Shearwater Petrel 1 & 2/Perdix/Perdix AI/NERD 2 Firmware v53 Release Notes

VERSION 53 2018.02.21

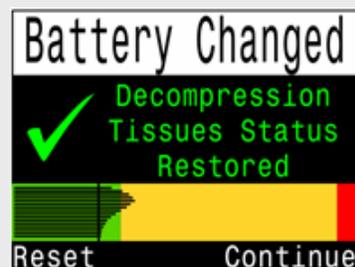
NEW After changing the battery, the current deco tissue loading is shown on the Tissues Restored screen.

NEW On the Tissues Restored screen, a shortcut to reset the tissues is given. If Reset is chosen, a prompt will be displayed to confirm. **Do NOT reset tissues between repetitive dives, as inert gas loading will be lost.**

The tissues bar graph is now shown on the Tissues Restored screen

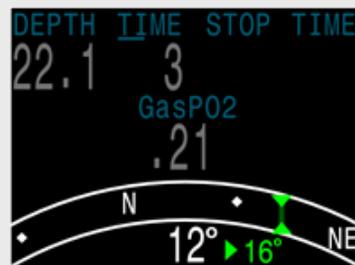
CHANGE Compass mark heading menu moved to reduce button presses. Also, the compass can now be viewed while marking. Operation: when viewing compass a left button press brings up an "Exit/Mark" menu. Right press marks compass, Left press exits to main screen. Previously had to navigate to regular menus to mark the compass.

The mark heading command now requires less button presses

IMPROVE When a heading is marked, the display now shows the offset angle between the current heading and the marked heading. This is useful for navigating patterns. For example, a box pattern requires turns at 90° intervals, while a triangle pattern requires turns at 120° intervals.

The offset between current and marked heading is now shown (in this example 16°)

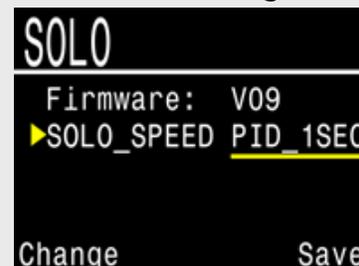
NEW Added support for changing settings on peripheral boards.

For example, on the SOLO board (solenoid and oxygen controller) the Solenoid Speed setting can be adjusted. Go to “Bus Devices” page on Petrel to access peripheral boards. Settings viewed here are stored on the peripheral device.

On the “Bus Devices” page, choose “View” to see more info and settings

If settings are available, they can be changed here. These settings are stored on the peripheral device.
